DESIGN	3	DRAWN BY	DART AEROSPACE HAWKESBURY, ONTARIO, CANAD	
	CHECKE	D #	APPROVED #	DRAWING NO. DSI 9357	REV. A SHEET 1 OF 2
1	DATE	1 40	<u> </u>	TITLE	SCALE
	06.10.25			CROSSTUBE SUPPORT CHANGE	NTS
	Α		06.10.25	NEW ISSUE

DART SERVICE INSTRUCTION

TO AMEND INSTALLATION INSTRUCTIONS IIN-D212-664 Rev. C AND INSTRUCTIONS FOR CONTINUOUS AIRWORTHINESS ICA-D212-664 Rev. 2

REF. CANADIAN STC: SH01-9 REF. FAA STC: SR01298NY

FIGURE 1 - CROSSTUBE SUPPORT INSTALLATION ON D412-664-203

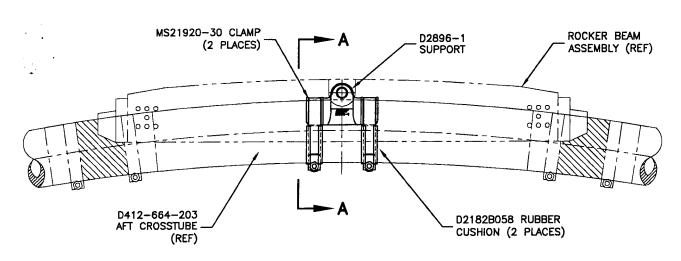
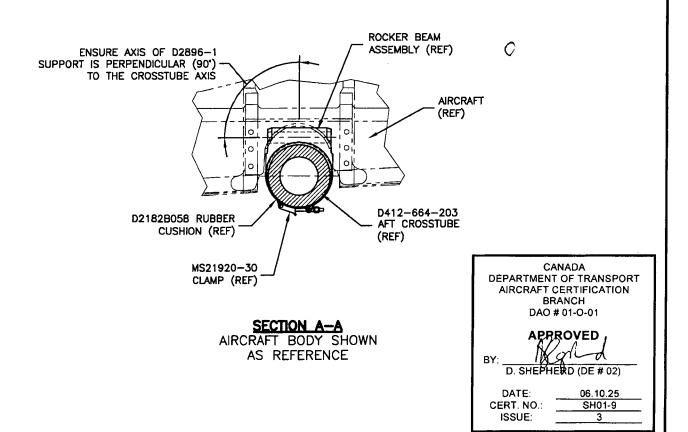
For D412-664-203 Aft Crosstubes at CHG 002 or later, the D2856-600-1087 Abrasion Strip has been removed, the center D2896-1 Support has been bonded onto the crosstubes using Magnobond 6398 and D2182B058 Rubber Cushions have been installed underneath the MS21920-30 Clamps. Amend Parts List of IIN-D212-664 Section 5 and ICA-D212-664 Section 32.8 as follows:

To prevent the center support from shifting on D412-664-203 Crosstubes at CHG 001, the D2896-1 Support should be removed and re-installed as follows:

- 5) Apply a 0.03" to 0.06" thick layer of Magnobond 6398 underneath D2896-1 Support and re-install the Support on the crosstube as shown in Figure 1. Use rocker beam assembly to properly align the D2896-1 Support. Ensure the Rocker Beam Assembly can move freely without any friction with other parts. Install a D2182B058 Rubber Cushion on each MS21920-30 Clamp. Position and secure the D2896-1 Support on the crosstube using MS21920-30 Clamps. Torque clamps 80-100 in lb. Let the D412-664-203 Crosstube Assembly cure before re-installing the crosstube or the aircraft.
